## DOCUMENT ADDENDUM FINAL PROPOSED ACCESS MANAGEMENT PLAN

## S.R. 39 FROM I-4 TO U.S. 301 HILLSBOROUGH AND PASCO COUNTIES, FLORIDA

Work Program Item Segment Nos: 255099 1 & 256289 1 Federal Aid Project No: F-321-1(4)

Florida Department of Transportation District Seven 11201 North McKinley Drive Tampa, Florida 33612 The attached Final Proposed Access Management Plan was completed in September 1999. This addendum provides updated project information that was not available in the previous Final Proposed Access Management Plan that was available for public review prior to and at the Public Hearing that was held on April 20, 2000. This addendum improves consistency between the Final Proposed Access Management Plan and the Environmental Assessment/Finding of No Significant Impact (EA/FONSI) that was approved by the Federal Highway Administration (FHWA) on November 14, 2000.

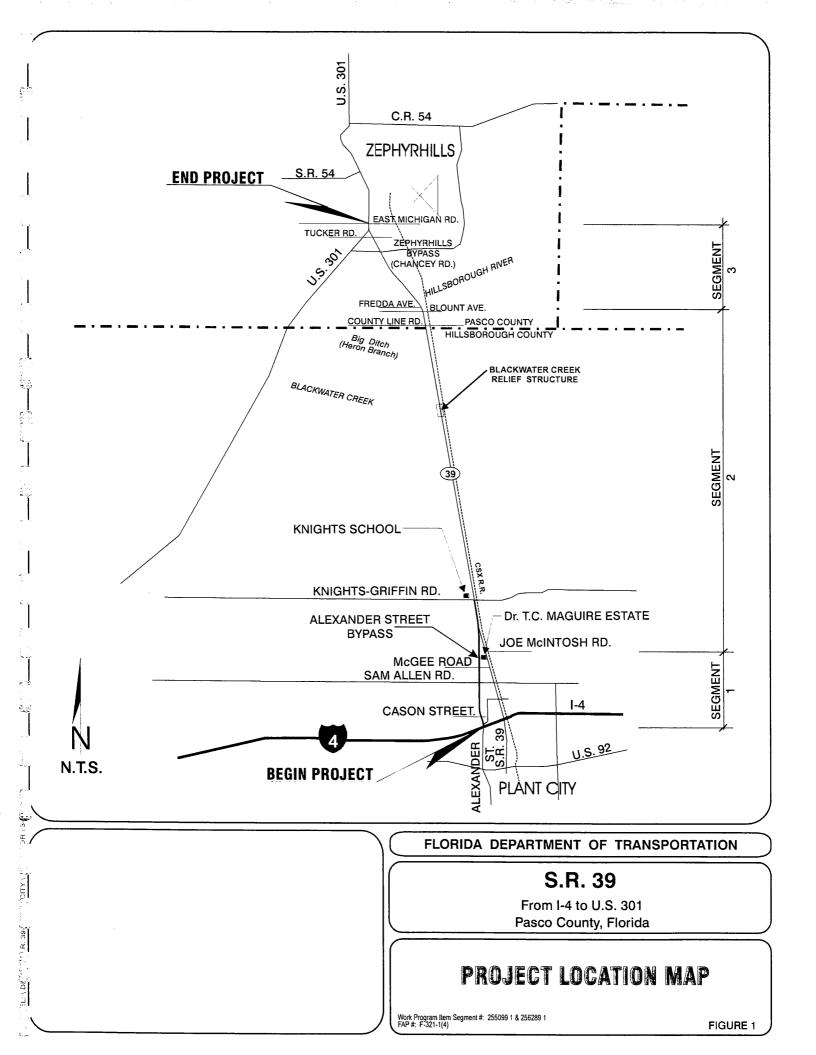
- Project Location Map has been updated (Addendum Figure 1).
- Refer to Table 9-3 in the Final Preliminary Engineering Report (October 2000) (PER) for proposed median openings.
- Refer to Appendix B in the PER for project aerial photographs of the preferred alternative.
- All current FDOT design standards are to be used.
- Existing posted speed limits along the S.R. 39 corridor vary between 72 km/h (45 mph) and 100 km/h (60 mph). Additional detail on posted speed limits is in the Project Traffic Intersection Analysis Technical Memorandum (November 1999) (Figure 6).
